PLANNING COMMISSION MEETING STAFF REPORT

DATE OF MEETING: September 14, 2021
NAME OF PROJECT: Eddington Small Subdivision
NAME OF APPLICANT: Summit Engineering representing Steven Eddington
AGENDA ITEM: Preliminary/Final Approval
LOCATION OF ITEM: Approx. 780 West 500 South
ZONING DESIGNATION: RA-1-43

EDDINGTON ONE-LOT SUBDIVISION

Subject: Eddington - 1 lot Subdivision – Preliminary / Final Approval

SHEET TITLE
SITE UTILITY PLAN

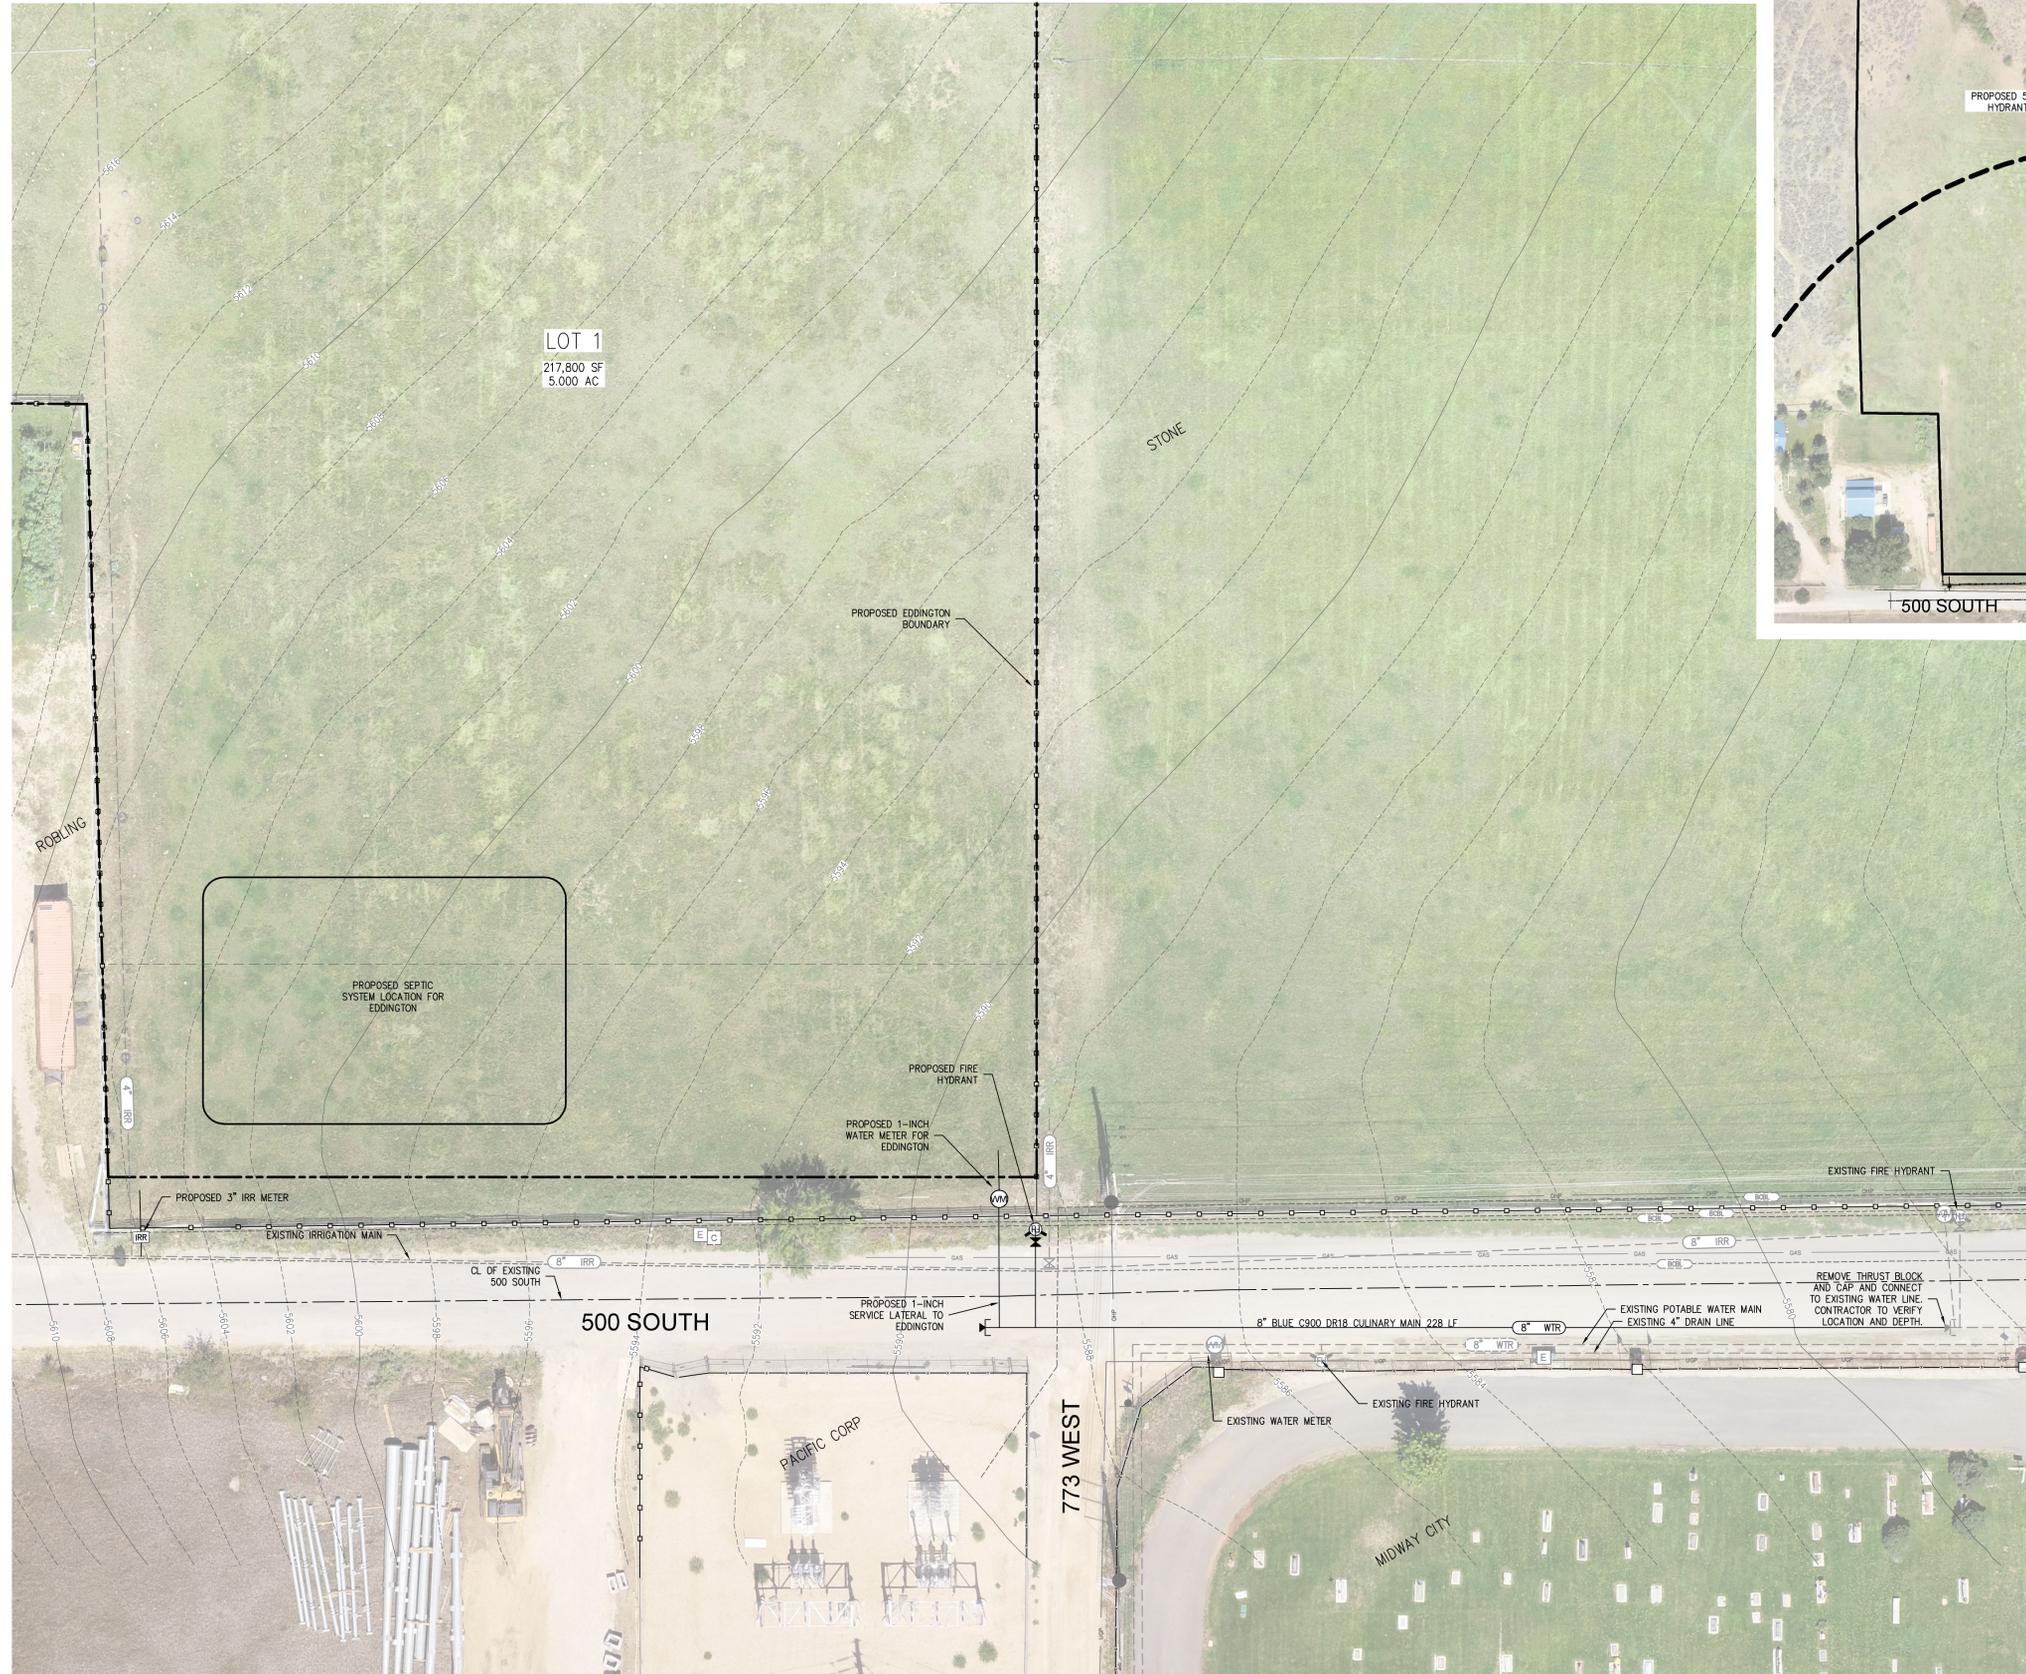
Culinary Water Connection – The lot will connect to the City’s water line located in 500 South. They will need to extend the line to the their west property line in 500 South.

Sewer Connection – The property will be served by an onsite septic system that will be approved by the Wasatch County Health Department. An approval letter from the Wasatch County Health Department regarding the septic system, must be provided before the item is added to a future city council agenda. The location of the approved septic site should be noted on the plat.

Secondary Water Connection – The property is currently connected to Midway Irrigation Company’s water system and this will continue with the new development. The applicant will need to provide a will serve letter from Midway Irrigation Company previous to being considered by the City Council.

Sensitive Lands – The applicant will need to identify all slopes of 25% and greater. These need to be noted on the plat and labeled as unbuildable. No other sensitive lands were identified by the applicants engineer.

Setbacks – The small-scale subdivision code requires a 50’ front setback for any proposed structures fronting 500 South. The required setback must be noted on the plat.

500 South – The applicant will need to show any required dedication needed for 500 South on the proposed plat. The portion of 500 South in front of the applicants property is considered a local road with a 56’ ROW. There are no additional road improvements that will be required as part of this proposal.

Trail – The Midway City Trail System Master Plan shows an 8’ detached asphalt public trail along the portion of 500 South that this property fronts. The applicant will

need to dedicate a 15' public trail easement along their front property line. In addition to the easement, staff is proposing that the funds to build the trail are added to the general trails fund for the city and the trail is completed in the future as part of a larger improvement project that will complete the trails along 500 South. The applicant will need to provide the city engineer with a cost estimate that will need to be reviewed and approved by him. The applicant has provided an estimate of probable costs, which will be reviewed by the city engineer for approval.

Fire Flow - A fire hydrant will need to be located within 500' of the future dwelling, measured by the route of a fire hose from the fire hydrant to the future home site.
